Project: Catskill Creek Waterfront Walkway. DOS Contract # C1000220
 Drawing Title: Addendum No.1 - Item No. 9 County Parking Lot Work Areas

Proj. No.: 14_001.1
 Sheet No.: C-1A

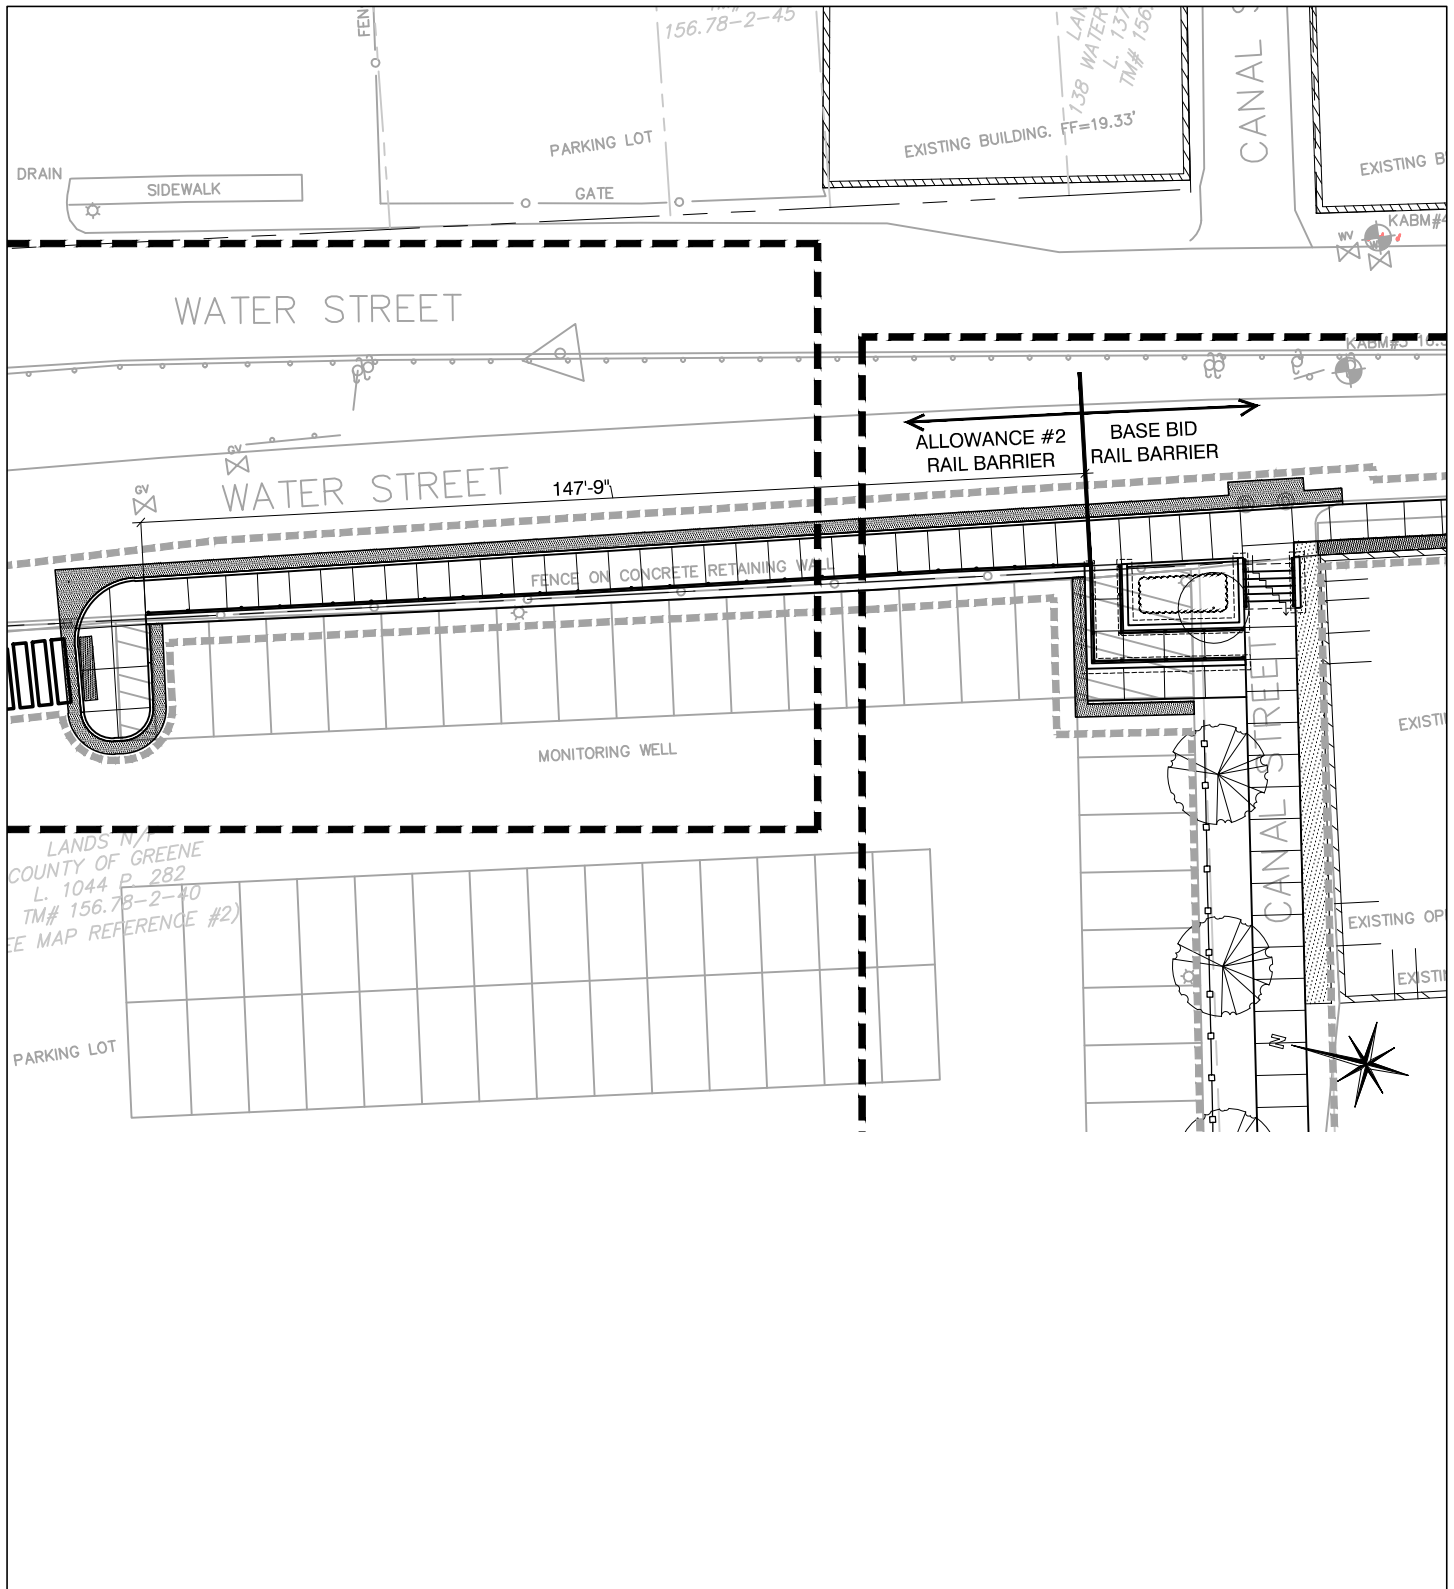
1. WORK AREA-1: PARALLEL PARKING SPACES MAY BE CLOSED AND USED BY THE CONTRACTOR FOR STAGING AND ACCESS FOR A DURATION UP TO A MAXIMUM OF 30 CONTINUOUS DAYS.
2. WORK AREA-2: HEAD-IN PARKING SPACES MAY BE CLOSED AND USED BY THE CONTRACTOR FOR STAGING AND ACCESS FOR A DURATION UP TO A MAXIMUM OF 60 CONTINUOUS DAYS.
3. WORK AREA-1 AND WORK AREA-2 MAY NOT BE SIMULTANEOUSLY CLOSED AT ANY TIME.
4. CONTRACTOR SHALL COORDINATE AND RECEIVE APPROVAL OF OWNER PRIOR TO CLOSING EITHER AREA FOR WORK A MINIMUM 7 DAYS PRIOR TO STARTING WORK IN EITHER AREA 1, 2 OR FOR REMARKING THE PAVEMENT.

Sheet No.: C-1B

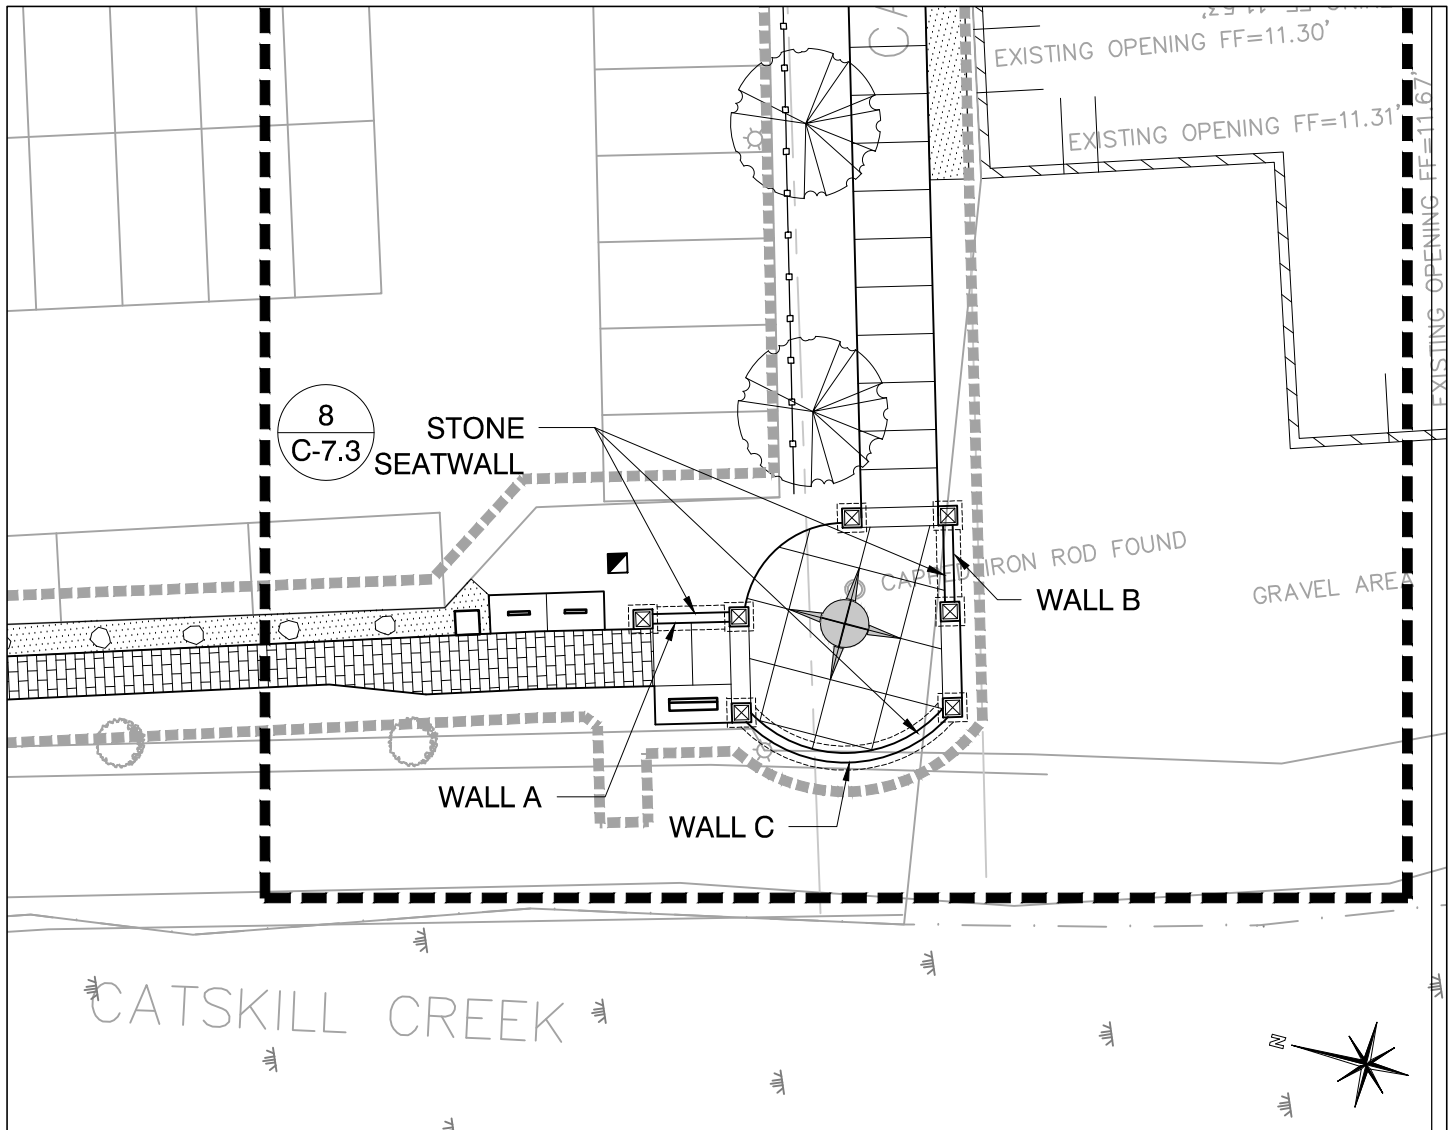
Drawing Title: Addendum No.1 - Item No. 7 Allowance # 2 Rail Barrier
